Cl 00 SC 0 P175 L 27 # 3212

Remein, Duane Huawei Technologies

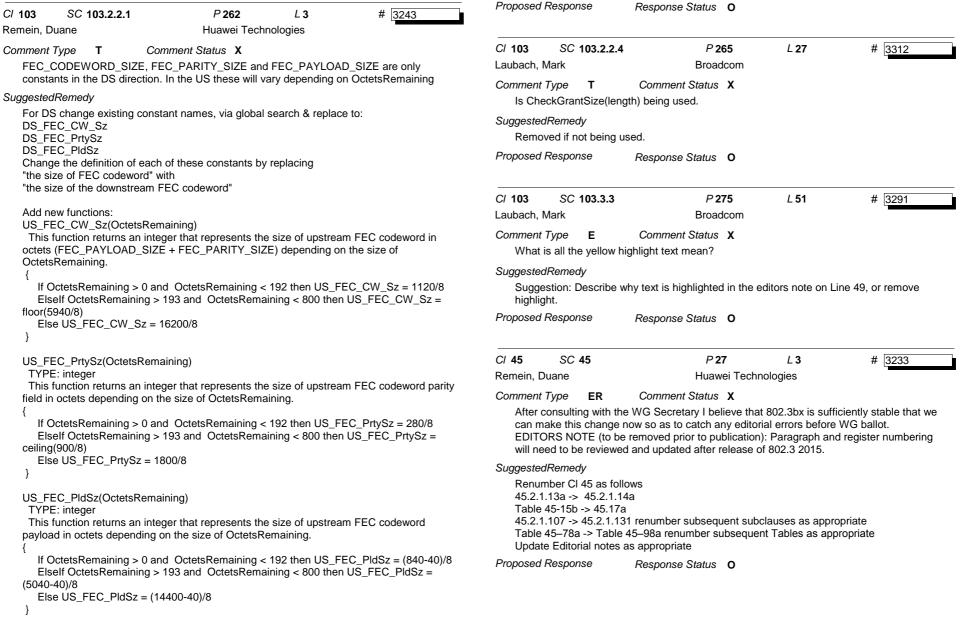
Comment Type T Comment Status X

derivation of values for FEC_PARITY_SIZE and FEC_PAYLOAD_SIZE can be less

NOT FINAL

Change value for FEC_PARITY_SIZE from "227" to
